Access Compliance Report Public Rights-of-Way (Curb Ramps)

Main Street: ST_VINCENT_PL Cross Street: BIMINI_DR Location: N

ADA ID: RPRK211013145003 Ramp Type: Type 6 - Directional 1 Initial Pass/Fail: Pass Overall Compliance: No Severity Score: 10

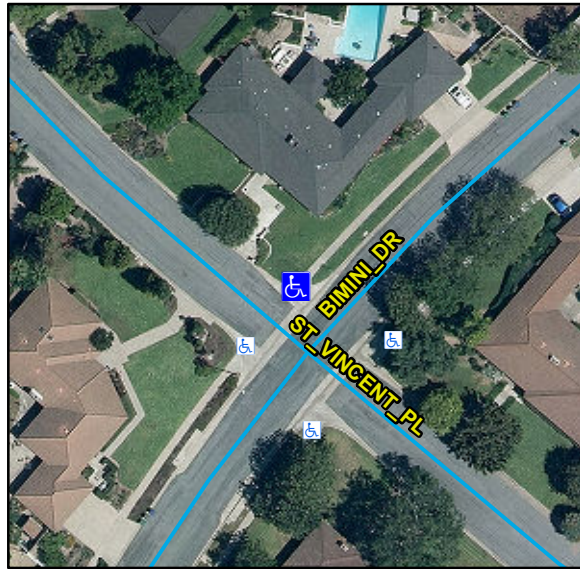
Compliance	Description	Data	Compliance	Description	Data
N/A	Ramp Length (in)	132	Yes	Flare Type LT	Curbed2
Yes	Ramp Width (in)	78			
Yes	Ramp Run Slope (%)	5.4	N/A	Flare Slope LT (%)	N/A
Yes	Ramp Cross Slope (%)	0.3	N/A	Flare Traversable LT	N/A
Yes	Grade Break	Yes	N/A	Flare Type RT	
Yes	Grade Break Slope (%)	1.3			Sloped
Yes	Grade Break Cross Slope (%)	0.6	N/A	Flare Slope RT (%)	8.2
	Addl Para Ramp Left?	No	N/A	Flare Traversable RT	No
	Addl Para Ramp Right?	No	No	DWS Provided	No
N/A	Landing Present	Yes	N/A	DWS Contrast	N/A
Yes	Landing Length (in)	50	N/A	DWS Length (in)	N/A
Yes	Landing Width (in)	48	N/A	DWS Full Width	N/A
Yes	Landing Run Slope (%)	0.1		DWS Offset Type	N/A
Yes	Landing Cross Slope (%)	1.4	N/A	DWS Left Offset (in)	N/A
N/A	Landing Movement Obstructed?	No	N/A	DWS Right Offset (in)	N/A
	Landing Movement Type	N/A			
N/A	Landing Shared	No			
N/A	Marked Crosswalk 1	No	N/A	Clear Space	N/A
	Crossing 1 Direction	SW	N/A	Clear Space To Crosswalk (in)	N/A

Marked Crosswalk 1 Width (in)	N/A			
N/A	Ramp Inside Crosswalk 1	N/A			
	Crossing 1 Slope (%)	1.4			
	Crossing 1 Cross Slope (%)	4.5			
Yes	Gutter Ponding	No	Yes	Curb Slope	4
Yes	Gutter Lip Height (in)	0		Road Run Slope (%)	N/A
Yes	Gutter Run Slope (%)	1.8		Road Cross Slope (%)	N/A
Yes	Gutter Cross Slope (%)	1.8		Parallel Ramp Side	Left
Yes	Overall Surface Condition	Acceptable	Yes	Perp Joint Present	Yes
	Cross Gutter Present?	Yes		Spandrel Present?	Yes
	Replace Cross Gutter?	No		Replace Spandrel?	No

Possible Solutions:

Install Detectable Warning System.
